From: Scala, Mary Joy
Sent: Thursday, August 27, 2015 9:33 AM
To: Jill Trischman-Marks (jtmarks@embarqmail.com)
Cc: 'bpritchard@b-h-a.com'
Subject: BAR Action - August 18, 2015 - 408 Park Street

BAR 15-08-02

408 Park Street

**CITY OF CHARLOTTESVILLE
BOARD OF ARCHITECTURAL REVIEW
STAFF REPORT
August 18, 2015**

CONCEPTUAL DEMOLITION PLAN
Scale: 1/8" = 1'-0"

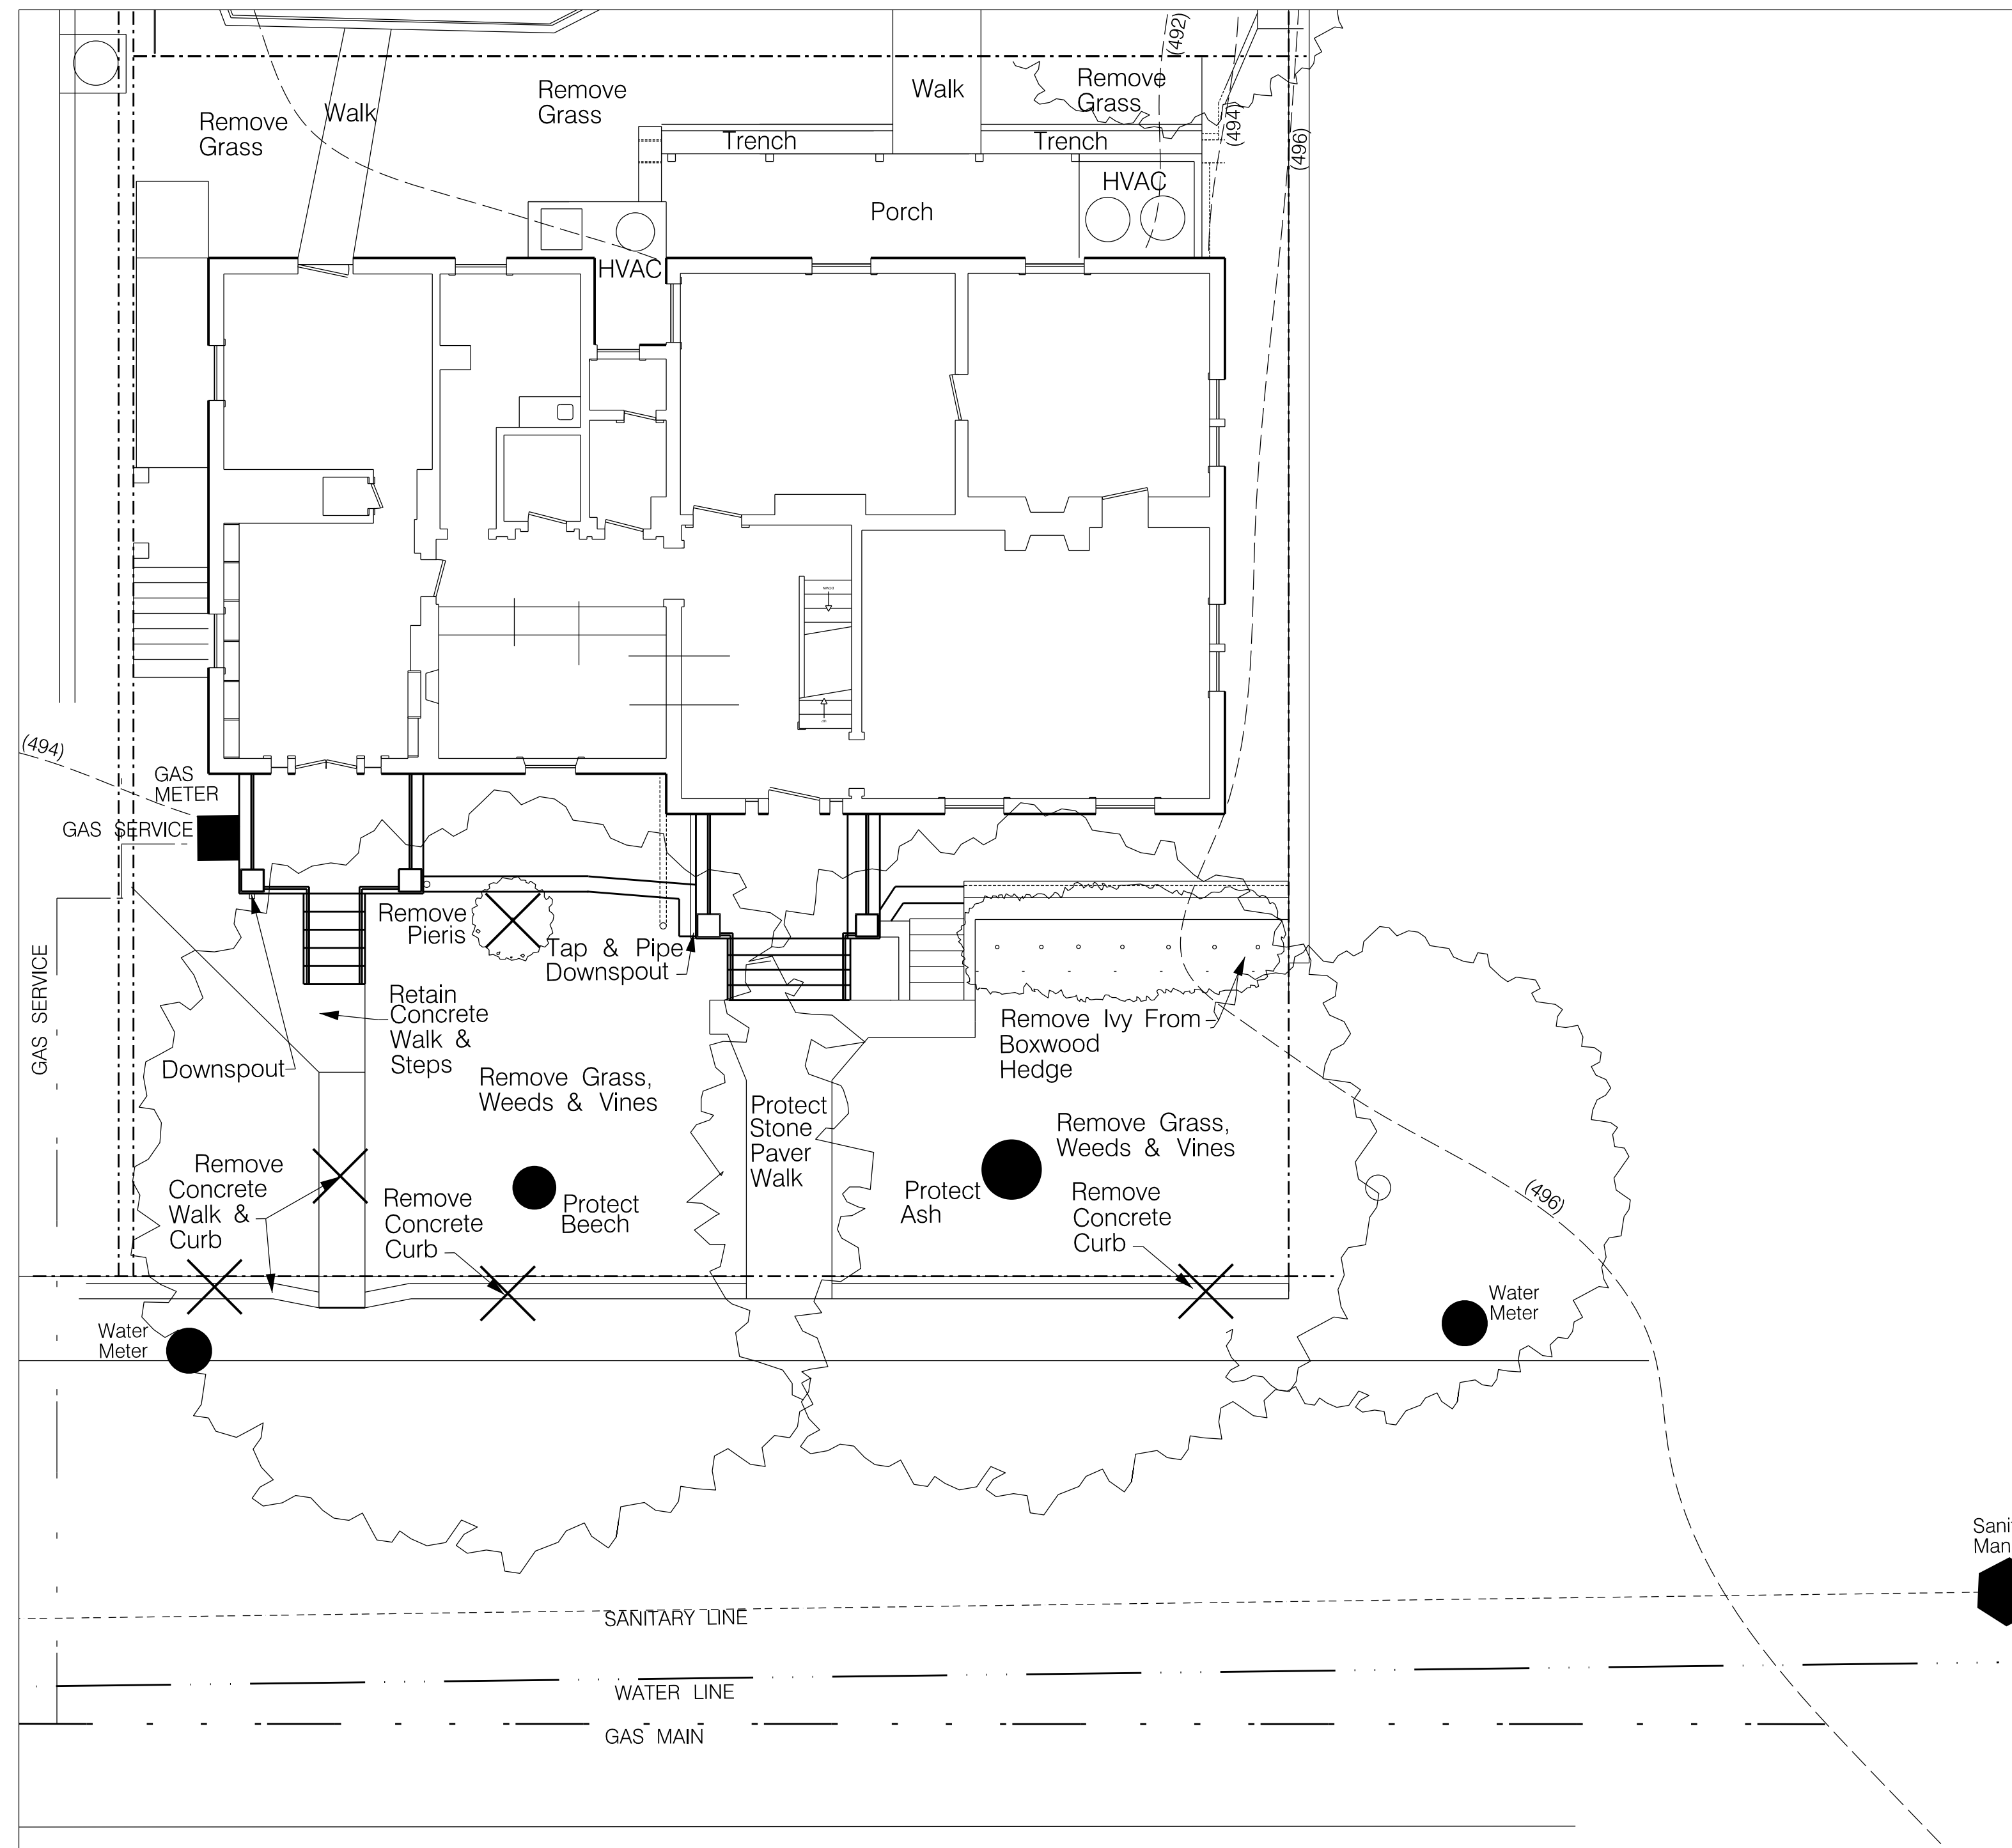
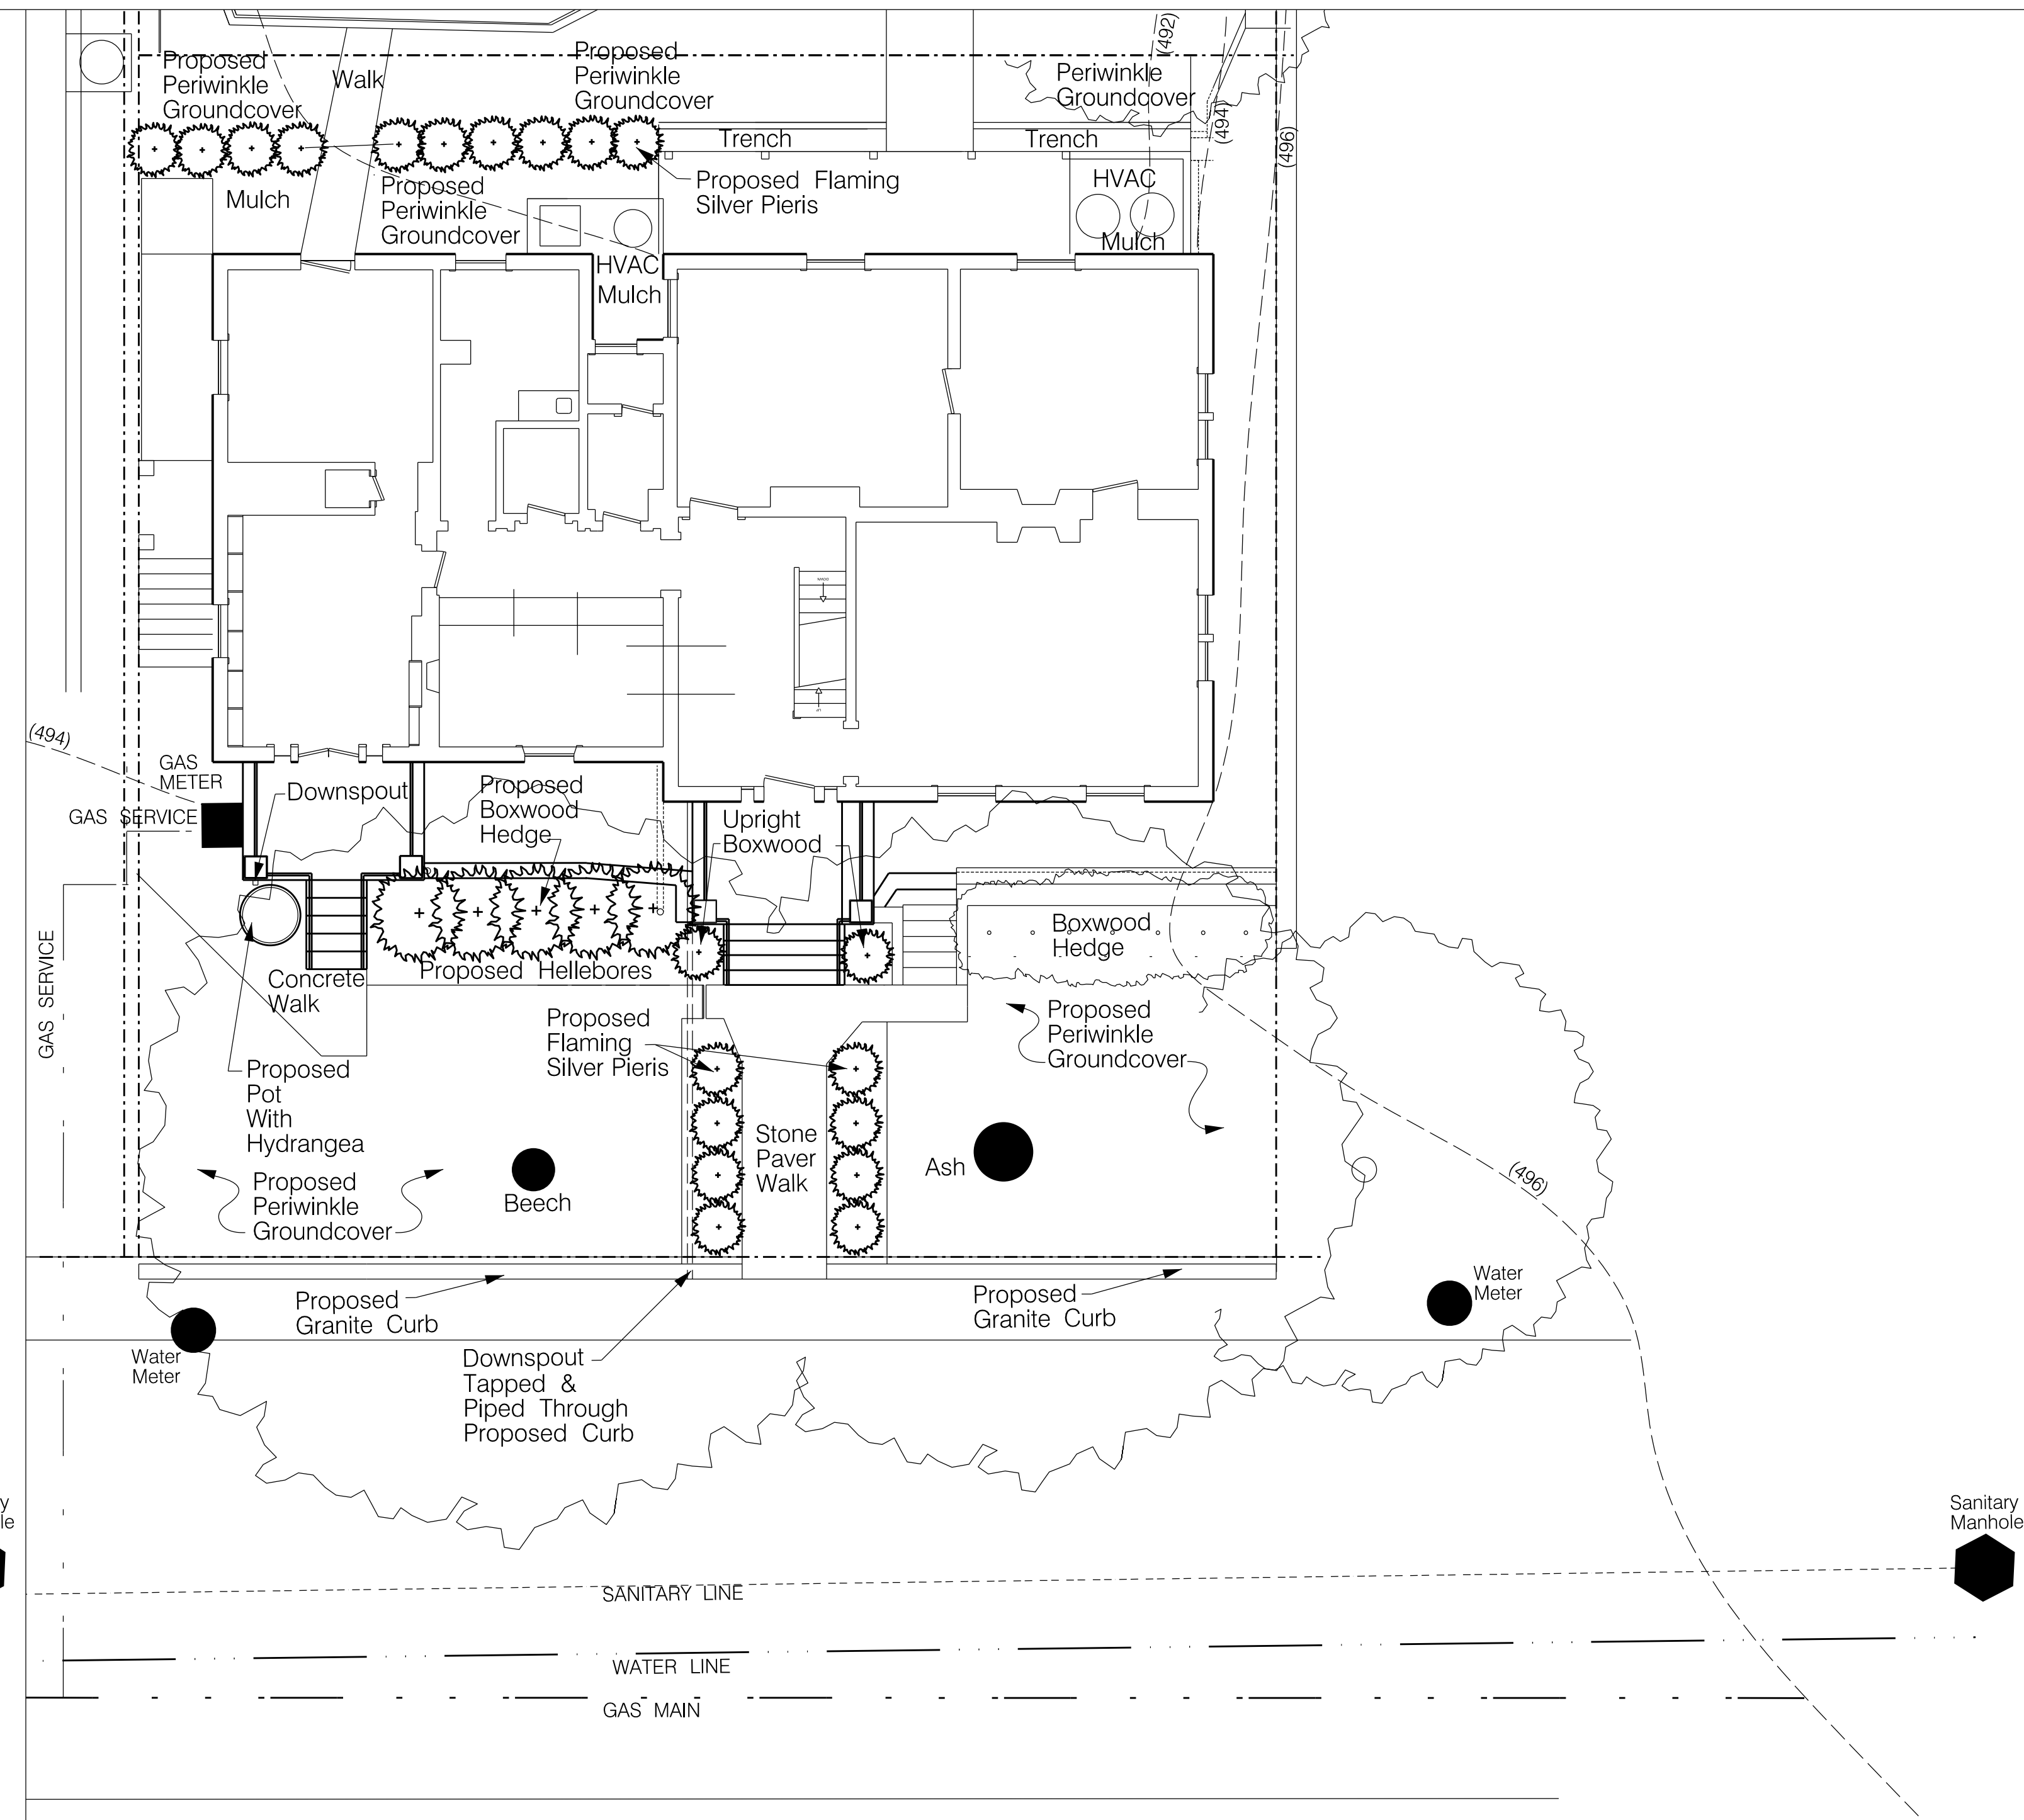
- **The left front concrete walk to be replaced with blue stone or slate stepping stones or similar**
- **The landscaping changes are approved, with the exception of the plantings along the existing stone paver walk (which revised plantings will be approved administratively)**
- **Replacement in kind of the quarter round concrete curbing with a similar aggregate mix, so to match the historic concrete as closely as possible (with same finish and scoring; OK to strike a straightened line with sidewalk) and**
- **The underground piping to extend the downspout drain into the yard, not to the sidewalk**

Removing part of the secondary walkway seems like a good solution, because the porch, stair and landing will remain. The landscape plan also seems simple and appropriate.

The BAR needs to discuss the appropriateness of the proposed concrete curb removal, given the recent denial of a similar request on West High Street. The BAR should not approve the removal of the curbing unless it can adequately distinguish the two applications.

Drainage may not be directed to the City sidewalk. Stormwater should daylight at the edge of pavement, not over a sidewalk; otherwise it could be a safety issue in the winter. A trench drain across the sidewalk would be acceptable; it needs to be load bearing and the lid for the trench drain should be slip resistant.
